**Colorado Springs Airport Advisory Commission Meeting
To Be Heard July 22, 2020
Land Use Review Item #07**

EL PASO COUNTY BUCKSLIP NUMBER(S)/FILE NUMBER(S): SKP202 SKETCH PLAN AMENDMENT - RESIDENTIAL		PARCEL #(S): 5500000332 5500000414
DESCRIPTION: Request by Dakota Springs Engineering on behalf of Rankin Holdings, LP for approval of the Waterview Sketch Plan amendment. The amendment includes modifying 52.9 acres of industrial (P-14) and 16.1 acres of commercial (P-15) to single-family residential creating a new parcel (P-19) on plan for 69 acres of residential. An additional 5.2 acres from parcel P-17 will be modified from commercial to multi-family residential and create a new parcel (P-21). The property is currently zoned I-2 (Limited Industrial). The property is located northeast of Powers Boulevard and Bradley Road. <i>Review Note: An amendment to the sketch plan was reviewed with recommended conditions by the Commission in July 2018. The most recent review for development south of this area was Trails at Aspen Ridge final plat in March 2020 (Tabled from December 2019).</i>

PROJECT LOCATION EXHIBIT:

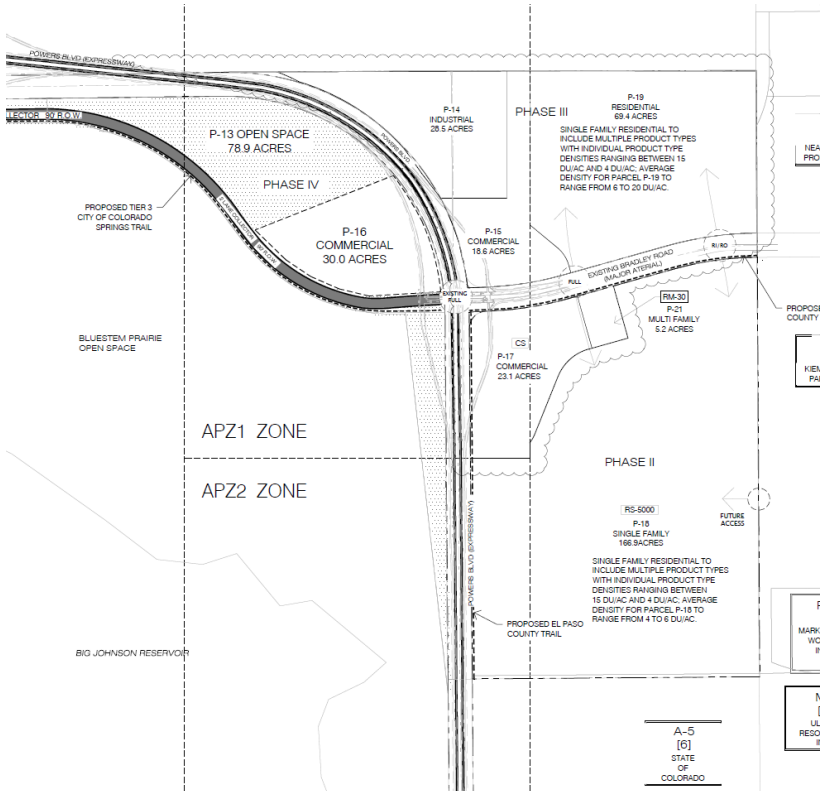
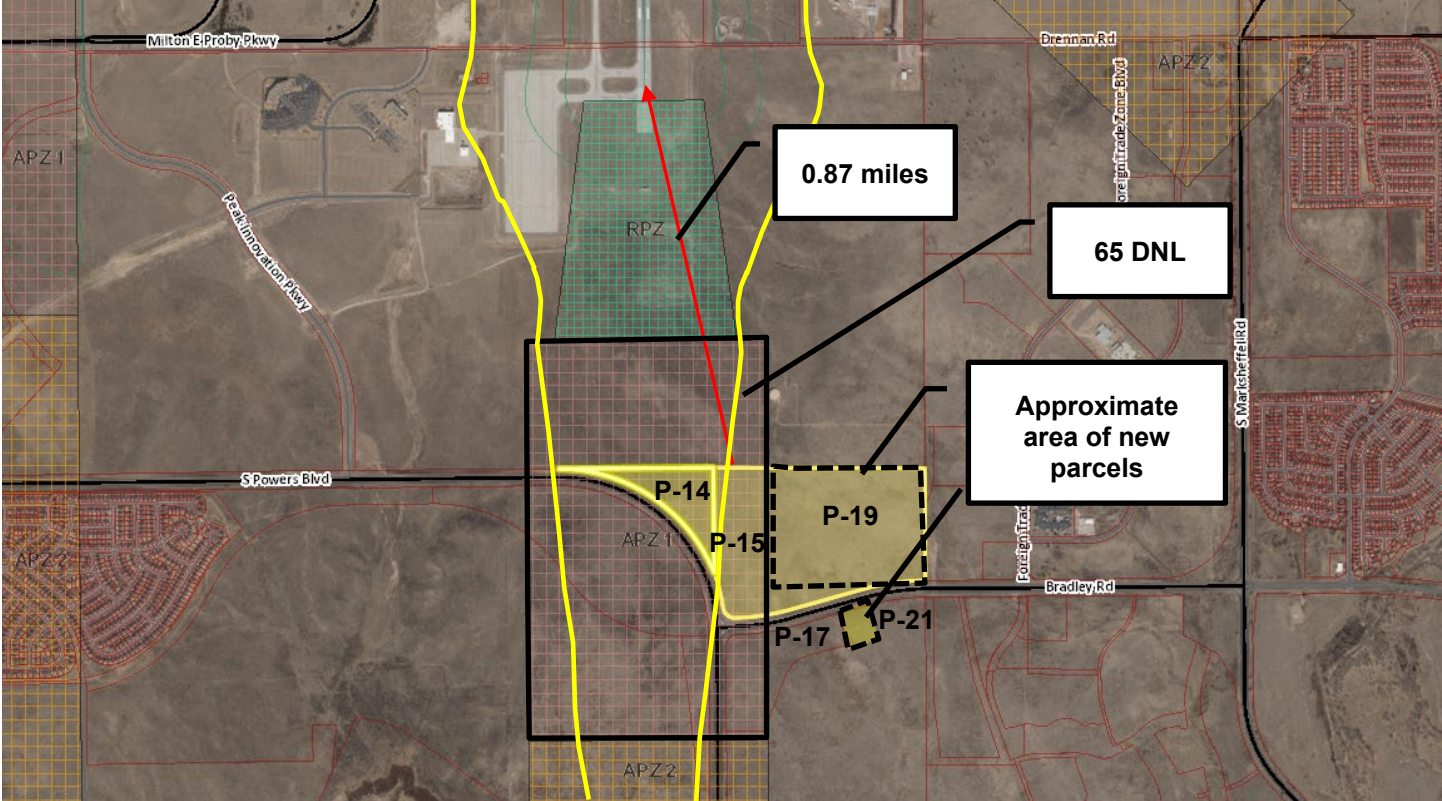
- **Avigation Easement:** An avigation easement is requested or provide proof of previous recording (book/page or reception number).
- **ADNL Noise:** The industrial and commercial parcels are within the ADNL Airport Noise subzone. These uses are permissible within the ADNL subzone. If any portion of the proposed structure will be used as an office, the applicant should demonstrate intent to comply with the indoor noise reduction requirement outlined in Section 4.3.1 of the El Paso County Land Development.

- **APZ-1:** The proposed development is within the Accident Potential Zone 1 (APZ-1) subzone of the Commercial Airport Overlay District, as adopted by El Paso County. The proposed uses (commercial) requires special use approval while industrial appears to be permissible in the APZ-1 subzone.

- **FAA Form 7460-1:** Based on elevation data, the applicant will need to file Federal Aviation Administration (FAA) Form 7460-1 "Notice of Proposed Construction or Alteration" for any new vertical development at this site, including temporary construction equipment, and provide FAA documentation to the Airport before the commencement of construction activities; FAA's website (<https://oeaaa.faa.gov/oeaaa/external/portal.jsp>).
